IDAHO DEPARTMENT OF WATER RESOURCES
PRELIMINARY RECOMMENDATION OF WATER RIGHTS ACQUIRED UNDER STATE LAW

RIGHT NUMBER: 23-11290

NAME AND ADDRESS: CONANT VALLEY RANCH
PO BOX 5546
ORANGE CA 92613

SOURCE: PRITCHARD CREEK

GIS Place of Use Illustration
1987/1988 NAPP Photography
Prepared by: A. Ruberry
Date: April 2004

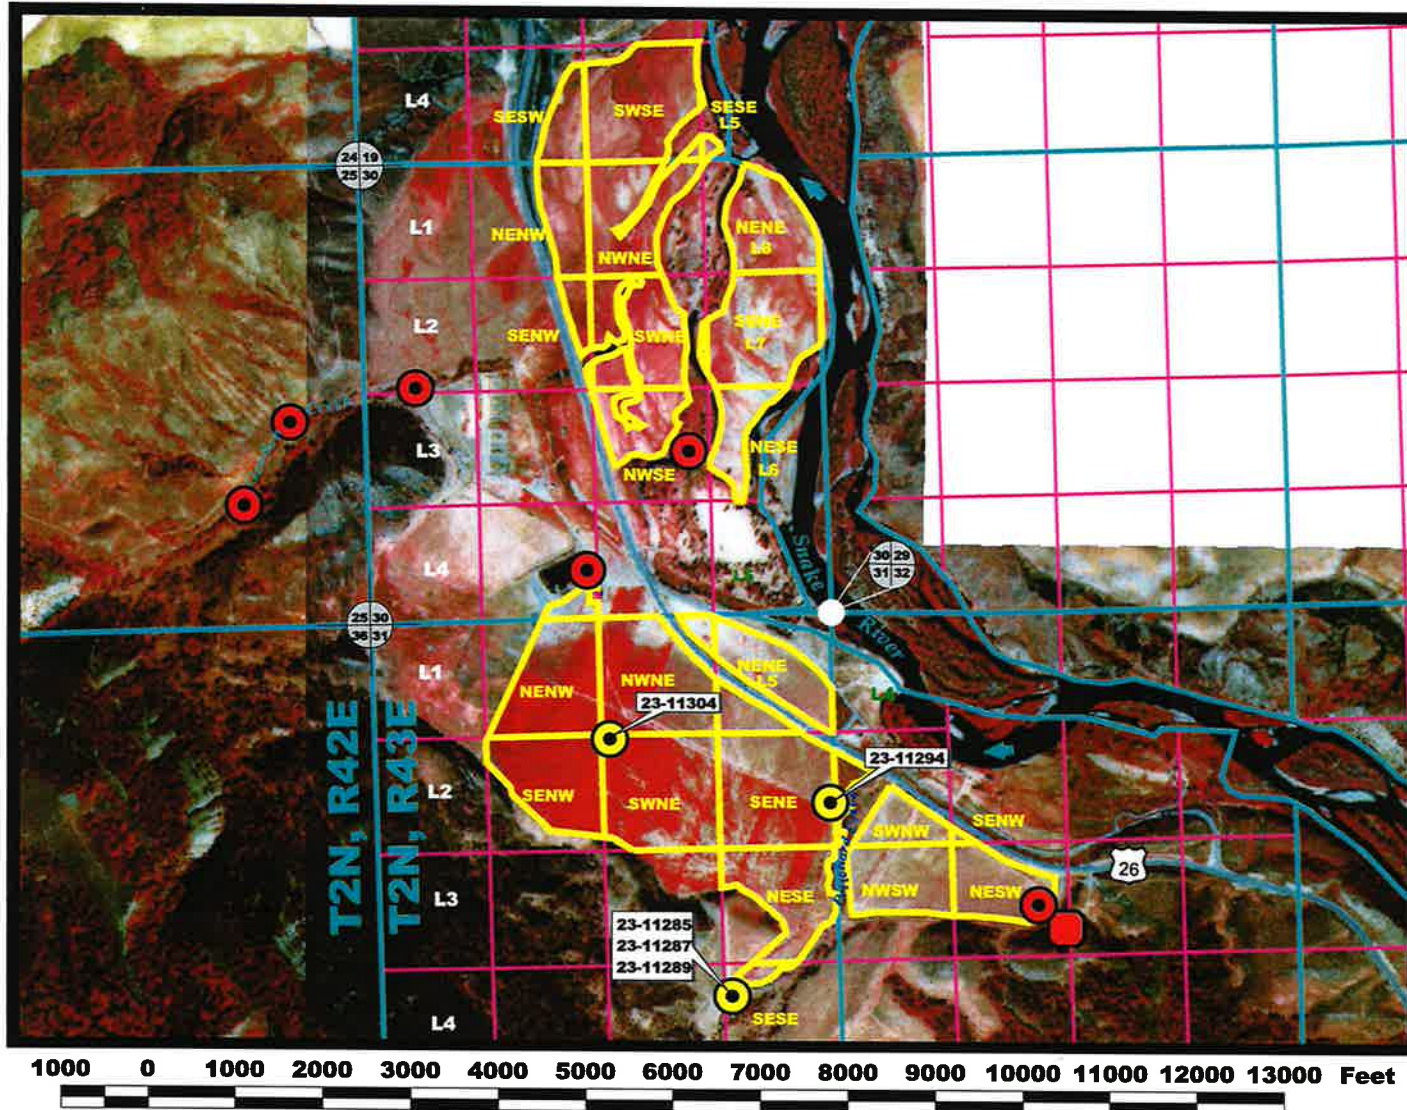
23-11286, 23-11288, and 23-11290 - The POU listed as T02N R43E S29 Lot 2 SWNW is a trespass on federal land. It should be deleted from the final recommendation.

4/26/04 POU ADJUSTED DUE TO BOR e-MAIL Directing
T2N R43E Sec. 29 LOT 2 (SWNW)
IS FEDERAL PUBLIC LANDS w/o A
FARM AGREEMENT.
